**VALERO REFINING  
COMPANY'S LAND USE  
APPLICATION FOR THE VALERO  
IMPROVEMENT PROJECT (VIP)**

*Environmental Impact Report*

SCH# 2002042122

*March 2003*

**Figure 4.2-1**  
 Valero Refinery Administration Building  
 Meteorological Station  
 Annual Flow Vector 1999-2001

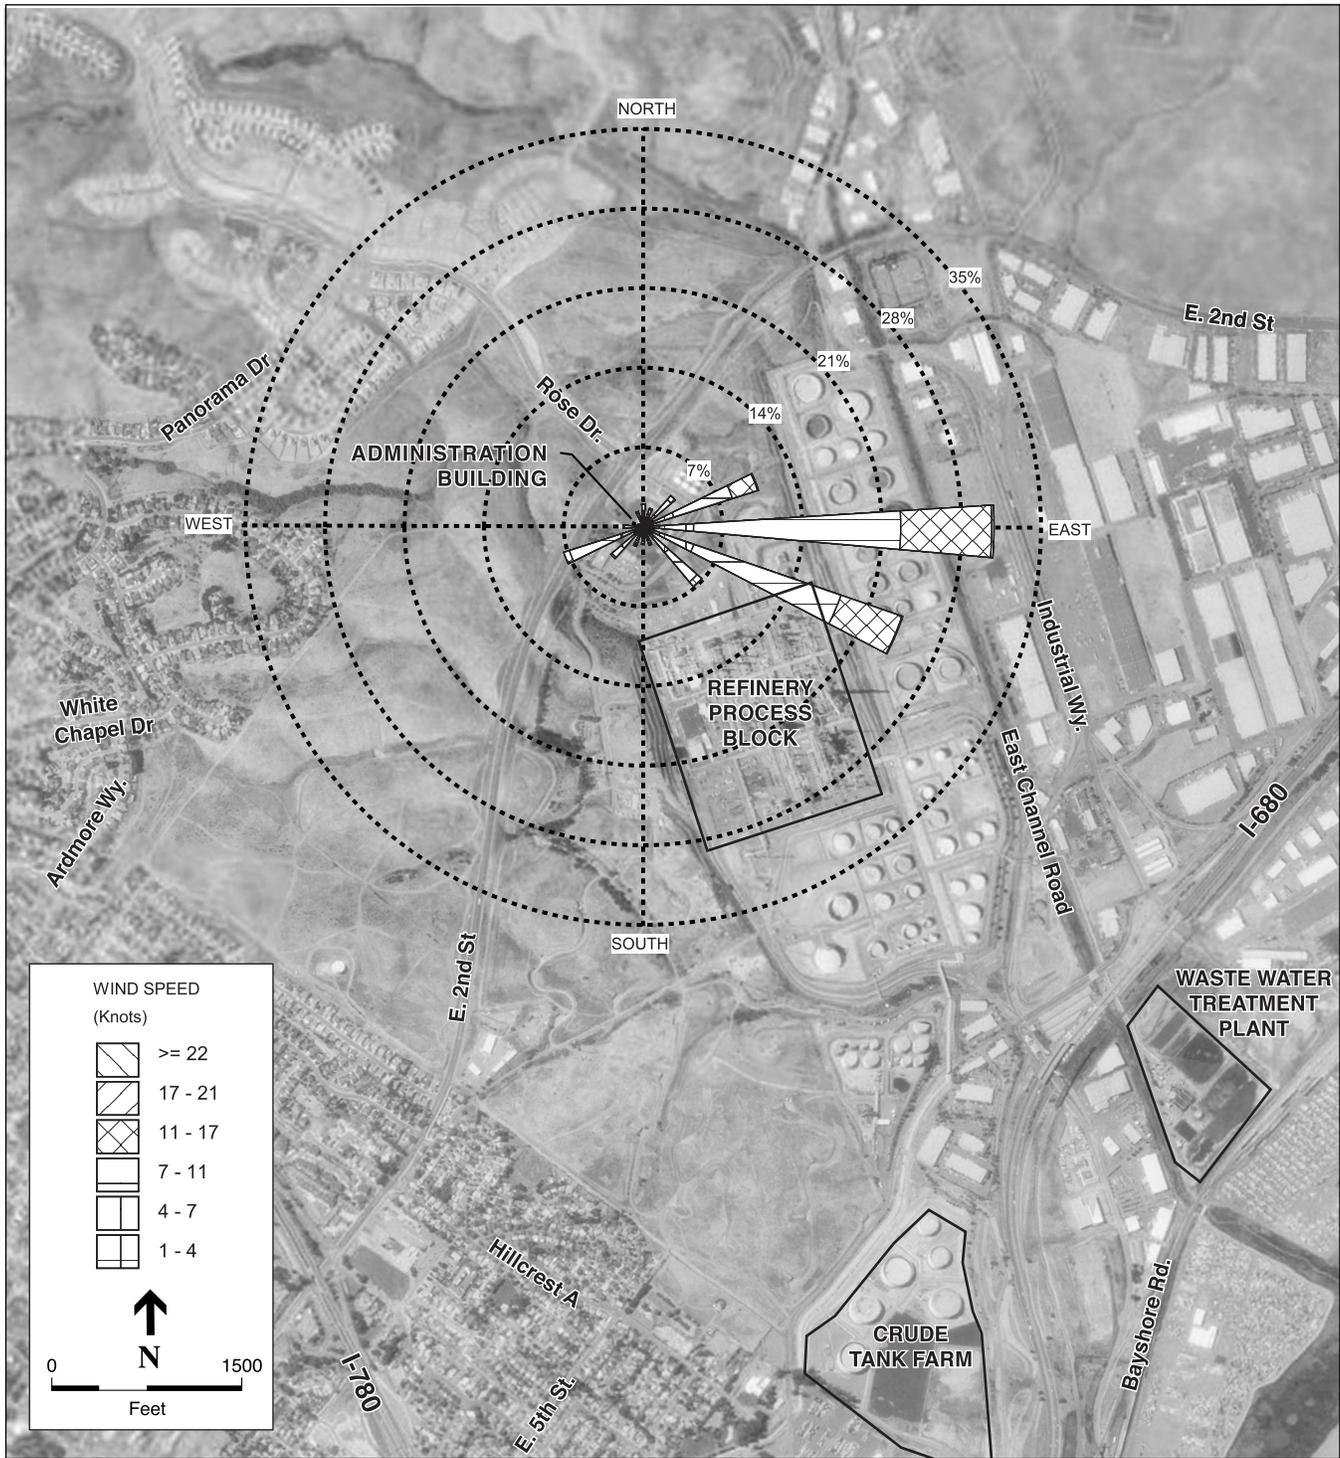
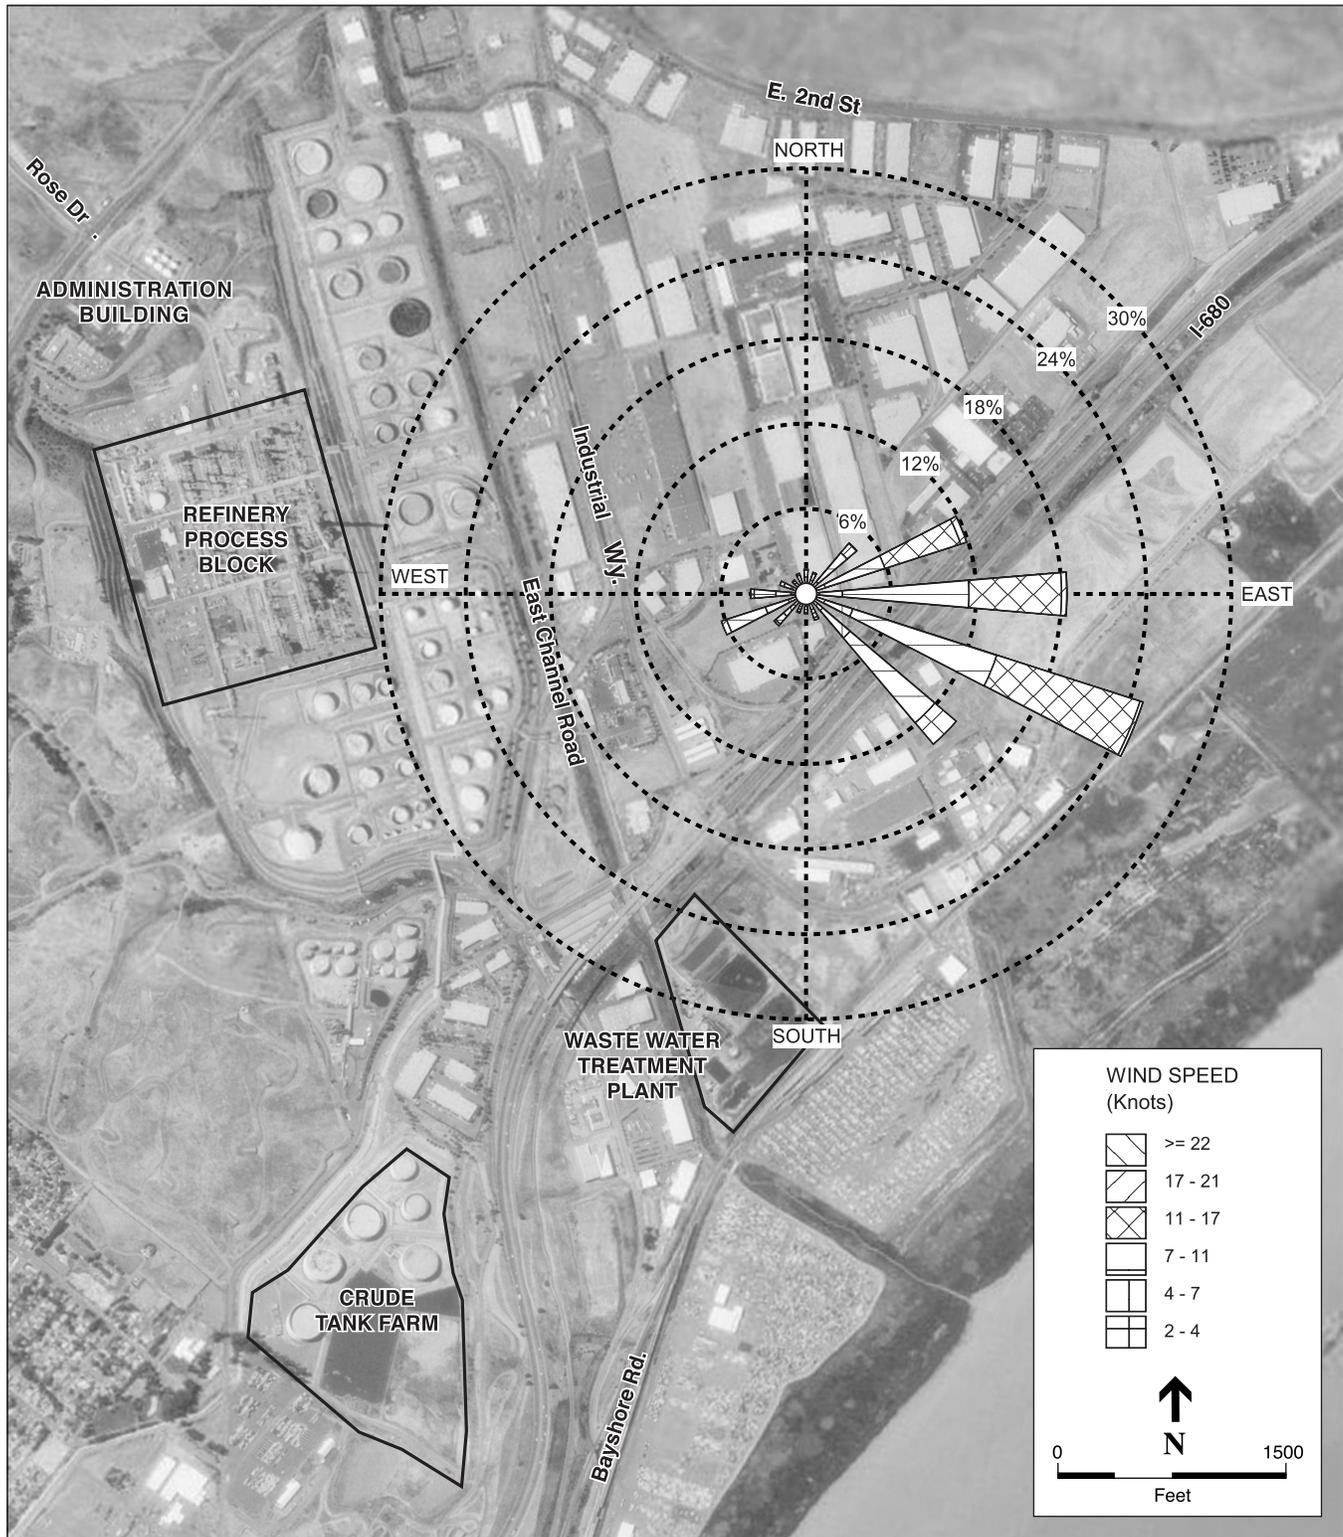
Commentors have requested information that has been gathered from local air quality monitoring stations and also have asked about the effects of local wind conditions on air quality.

Valero operates two meteorological towers on-site: one at the administration building on the west side of the site and the other on the east side of the refinery site. The meteorological data gathered at these two towers are regularly reported to the BAAQMD. Wind speed and direction data have been summarized and converted into "wind rose" diagrams, which summarize and show the frequency with which various combinations of wind speed and wind direction occur at each station. These wind roses are shown on Figures 4.2-1 and 4.2-2, which are added to the EIR. These figures show the frequency of wind speed and wind direction for the most current three years of data on an annual basis. To assist the understanding of these figures, they have been configured to show the "flow vector", which stretches out in the direction that the wind is blowing, i.e., if the figure shows a directional radial stretching toward the east, this identifies a "west wind", a wind that blows from the west over the refinery and toward the east.

These wind data show clearly that there is a strong westerly wind (from west to the east) much of the time, with a weaker return flow, from the east to the west, over the refinery. Interestingly, there is an approximately 15 degree directional difference between the winds at the two stations

Valero Improvement Project EIR / 202115  
**Figure 4.10-1**  
 Land Use Diagram

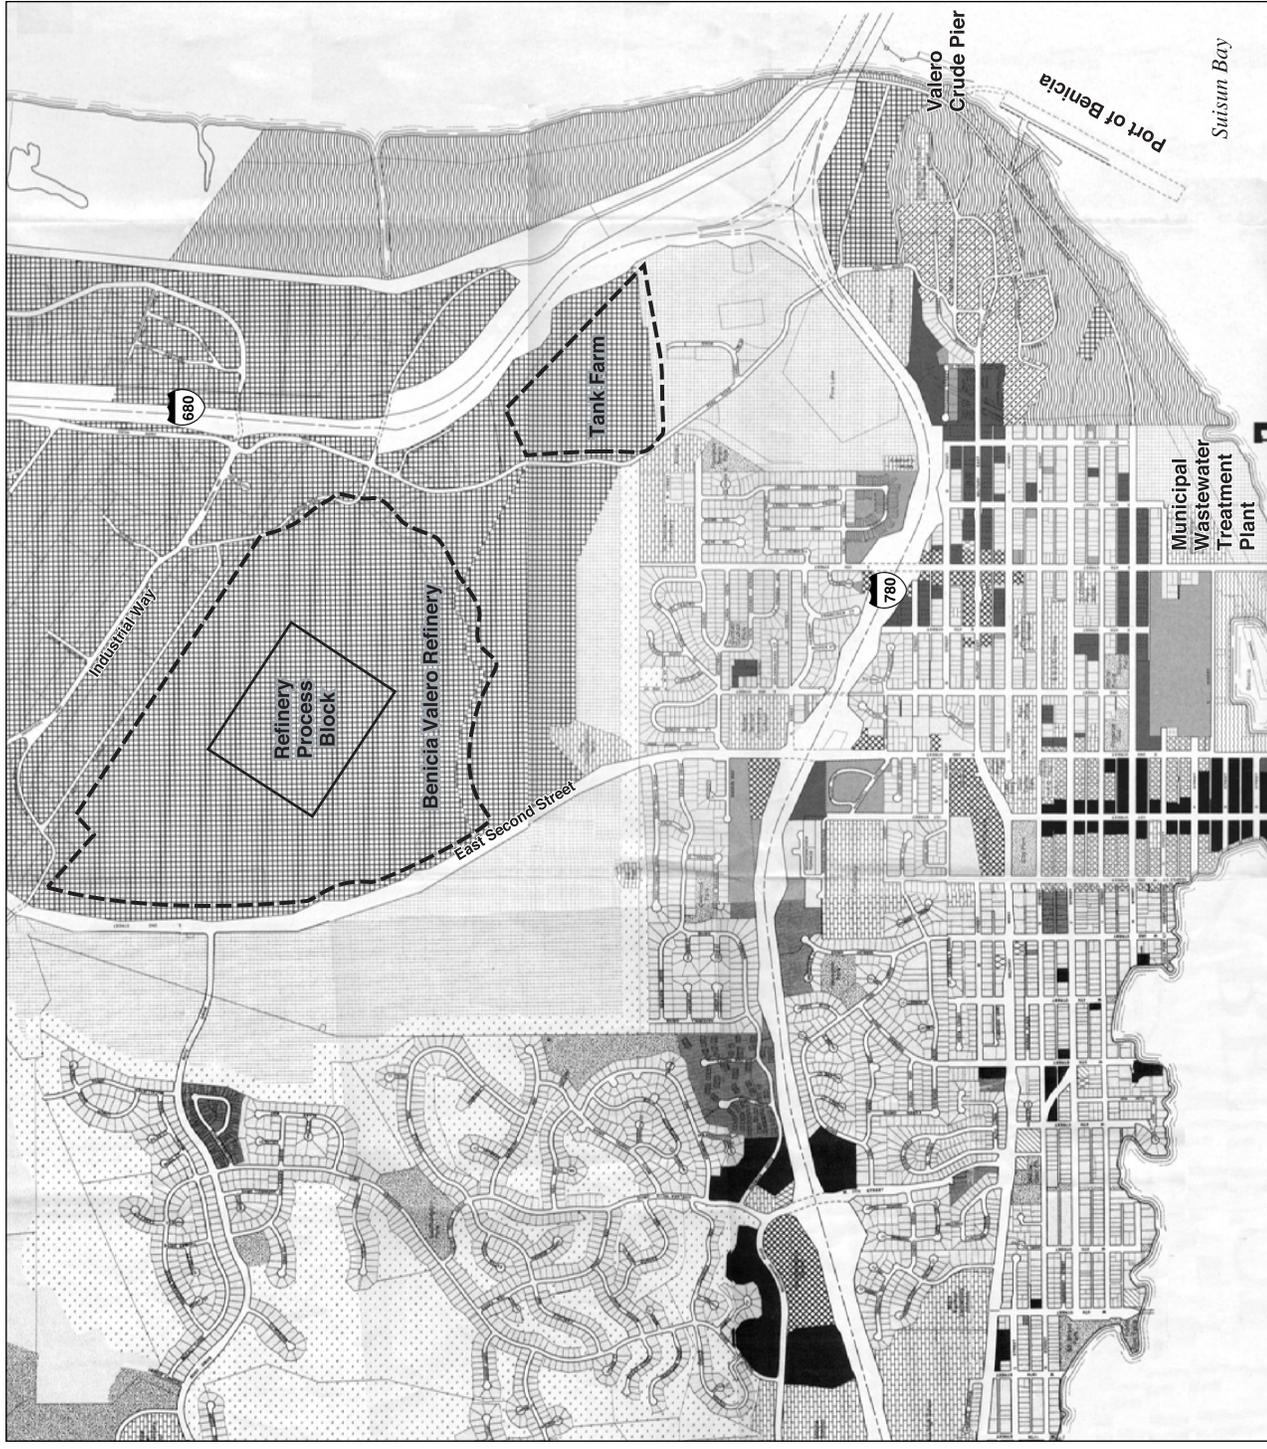
The "Land Use Diagram" included as Figure 4.10-1 refers to a Downtown Mixed Use area and an Arsenal Mixed Use area (see attached.) These areas have not yet been rezoned as mixed use. Currently, for example, the bulk of the area depicted as Downtown Mixed Use in Figure 4.10-1 is zoned Medium Density Residential.

- U1 Figure 4.10-1, Land Use Diagram, is derived from the City of Benicia’s Land Use Diagram dated June 1999. This figure accurately depicts the General Plan’s Downtown Mixed Use/Arsenal Mixed Use designations, not the zoning; those parcels have not yet been rezoned to conform to the land use designations in the General Plan.
